# Access Compliance Report Public Rights-of-Way (Pedestrian Signals)

**Main Street:** ORANGEWOOD\_AVE      **Cross Street:** LOS\_ALAMITOS\_BLV      **Location:** SE

**ADA ID:** SGRK211217115649    **Signal Type:** One Push Button-Non APS    **Overall Compliance:** No    **Severity Scores:**    **BTN 1:** 35    **BTN 2:** N/A    **No BTN:** N/A

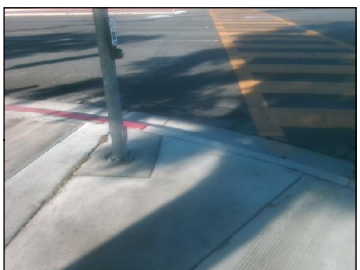
**OC Std/PROW:** MUTCD 4e.08, R404.2, R404.3

**Possible Solutions:** Replace Signal Push Button With APS Button. Remove & Relocate Sign.
